Subject: Transmittal of Revision 2 to Service Bulletin No. V2500-ENG-73-0015

ENGINE - FUEL AND CONTROL - INCORPORATE A NEW ELECTRONIC ENGINE CONTROL (EEC)

CONFIGURATION AND REWORK THE DATA ENTRY PLUG ASSEMBLY

TO THE SCN11E SOFTWARE CONFIGURATION

Location of electronic engine control and data entry plug assembly
Fig.1

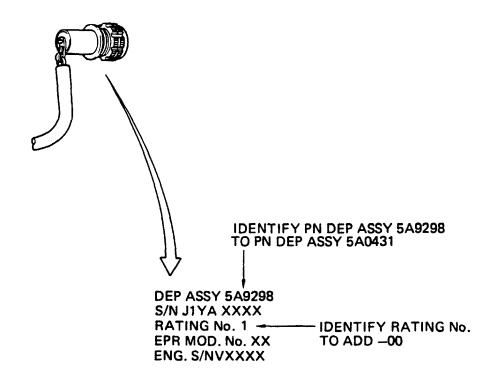
- (2) Loosen the Backshell Nut, but do not remove the Backshell. Use TG-70 Strap Wrench or equivalent.
- (3) Disconnect the Data Entry Plug Assembly from the EEC. Use the IAE1J12018 EEC Harness Wrench. Refer to Fig.1.

- (4) Remove the 2A2039 Electronic Engine Control by the approved procedure in Reference (3), Chapter/Section 73-22-34, Removal/Installation. Refer to Fig.1.
- C. Rework Instructions (For Engine Serial Numbers V0014 thru V0096 except V0034, V0039, V0051, V0053, V0054, V0055, V0058, V0060, V0061, V0081 and V0085).

- (1) Install 2A2189 Electronic Engine Control by the approved procedure in Reference (3), Chapter/Section 73-22-34, Removal/Installation by Fig.1 except as follows:
  - (a) Tighten and torque all the EEC Electrical Harness Connectors to 32 lbfin (3,6 Nm). Use the IAElJ12018 EEC Harness Wrench. See Reference (4), Chapter/Section 70-41-00, (TASK 70-41-00-400-501).
- (2) Connect the Data Entry Plug Assembly the the EEC. Refer to Fig.1.
- (3) Tighten and torque the Data Entry Plug Assembly to 32 lbfin (3,6 Nm). Use the IAElJ12018 EEC Harness Wrench. See Reference (4), Chapter/Section 70-41-00, (TASK 70-41-00-400-501).

Identification of 5A9298 data entry plug assembly with no modification Fig. 2

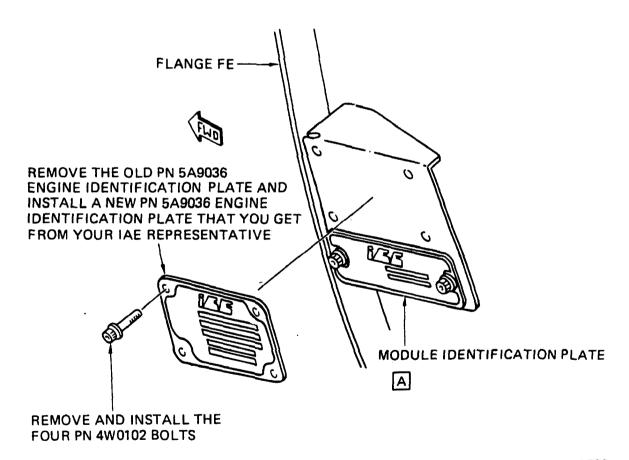
(a) Identify the Data Entry Plug Backshell with the New Part Number as follows:

(i) Mark out the Old Part Number (5A9298). Use the vibration peen method

(ii) Mark the New Part Number (5A0431) adjacent to the Old Part Number location. Use the vibration peen method Identify by the approved procedure in Reference (4), Control No./TASK 70-09-00-400-501.

(iii) Vibro-peen -00 after the Rating Number now on the Data Entry Plug Backshell Identify by the approved procedure in Reference (4), Control No./TASK 70-09-00-400-501

Location of the engine identification plate Fig. 3

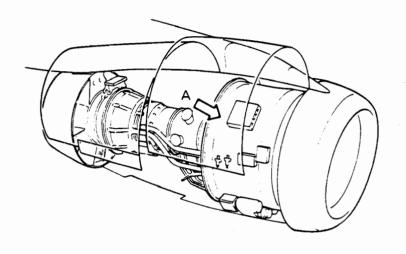
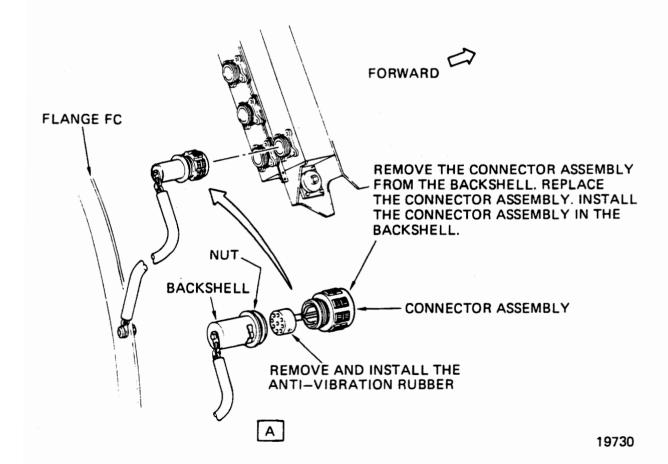
(a) Remove the four bolts that hold Refer to Fig. 3, requirements the Engine Identification Plate to the bracket located on the fan case at the 9 o'clock position

(b) Get the new 5A9036 Engine Identification Plate marked with the engine serial number, data entry plug part number, and take-off rating, from your IAE Representative

(c) Install the new Engine Identification Plate to the bracket with the 4W0102 Bolts (4 off) Refer to Fig. 3, requirements

- (d) Torque the bolts between Refer to Fig.3, requirements 32 36 lbfin (3.61 4.07 Nm)
- D. Rework Instructions (For Engine Serial Numbers V0034, V0039, V0051, V0053, V0054, V0055, V0058, V0060, V0061, V0081 and V0085)
  - (1) Do a modification to 5A9298 Data Entry Plug (See Reference (2), Chapter/Section 73-22-35, Fig/Item No.01-100) and identify as follows:

Identification of 5A9298 data entry plug assembly with a modification Fig.5

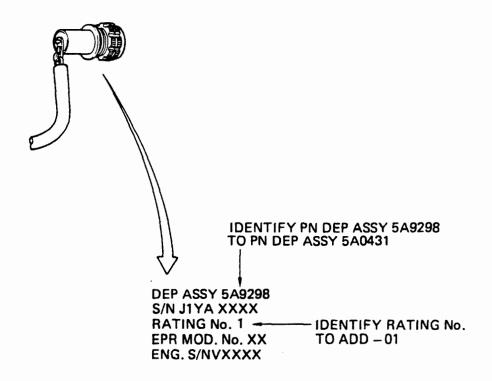
(f) Identify the Data Entry Plug Backshell with the New Part Number as follows:

(i) Mark out the Old Part Number (5A9298). Use the vibration peen method

(ii) Mark the New Part Number (5A0431) adjacent to the Old Part Number location.
Use the vibration peen method

(iii) Vibro-peen -Ol after the Rating Number now on the Data Entry Plug Backshell Identify by the approved procedure in Reference (4), Control No./TASK 70-09-00-400-501

Identification of 5A0357 data entry plug assembly with a modification Fig.6

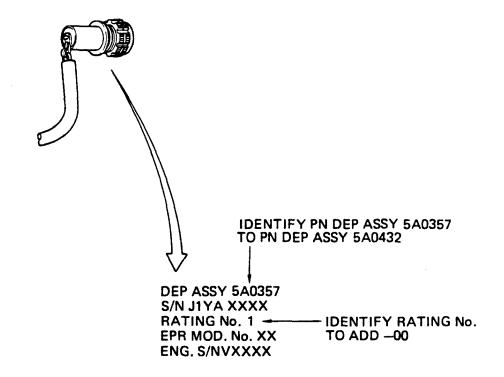
(f) Identify the Data Entry Plug Backshell with the New Part Number as follows: Refer to Fig.6, requirements

(i) Mark out the Old Part Number (5A0357). Use the vibration peen method

(ii) Mark the New Part Number (5A0432) adjacent to the Old Part Number location.
Use the vibration peen method

(iii) Vibro-peen -00 after the Rating Number now on the Data Entry Plug Backshell
